# Access Compliance Report

## Public Rights-of-Way

### (Curb Ramps)

Intersection ID: 42593	Main Street: W_MOREHEAD_ST	Cross Street: W_JOHN_BELK_RA	Location: SE
ADA ID: 44750915A564	Ramp Type: Perp	Initial Pass/Fail: Fail	Overall Compliance: No
Severity Score: 46.25			
Codes/Mitigation Info/Possible Solution		Field Measurements/Component Compliance

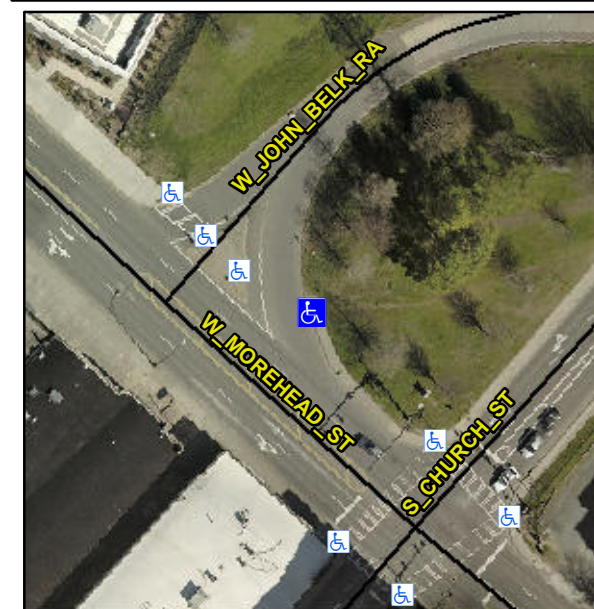
**Not Found, R304.5.1, R304.2.2, R304.5.3**

Compliance	Description	Data	Compliance	Description	Data
N/A	Ramp Length (in)	62.0	No	Ramp Slope (%)	15.9
No	Ramp Width (in)	45.0	No	Ramp XSlope (%)	6.9
N/A	Flare Type LT	N/A	N/A	Flare Type RT	N/A
N/A	Flare Slope LT (%)	N/A	N/A	Flare Slope RT (%)	N/A
N/A	Flare Traversable LT?	N/A	N/A	Flare Traversable RT?	N/A
N/A	Landing Length (in)	N/A	N/A	DWS Provided?	N/A
N/A	Landing Width (in)	N/A	N/A	DWS Contrast?	N/A
N/A	Landing Slope (%)	N/A	N/A	DWS Length (in)	N/A
N/A	Landing X Slope (%)	N/A	N/A	DWS Full Width?	N/A
N/A	Landing Curb? (Y/N)	N/A	N/A	DWS Offset (in)	N/A
N/A	Shared Landing?	N/A			
N/A	Gutter Ponding?	N/A	N/A	Gutter Slope (%)	N/A
N/A	Gutter Lip Ht (in)	N/A	N/A	Gutter X Slope (%)	N/A
N/A	Painted X Walk1?	No	N/A	Painted X Walk2?	N/A
	X Walk 1 Direction	To NW		X Walk 2 Direction	N/A
N/A	X Walk 1 Width (in)	N/A	N/A	X Walk 2 Width (in)	N/A
	X Walk 1 Slope (%)	2.8		X Walk 2 Slope (%)	N/A
	X Walk 1 X Slope (%)	7.9		X Walk 2 X Slope (%)	N/A

**Remove & Replace Entire Ramp.**
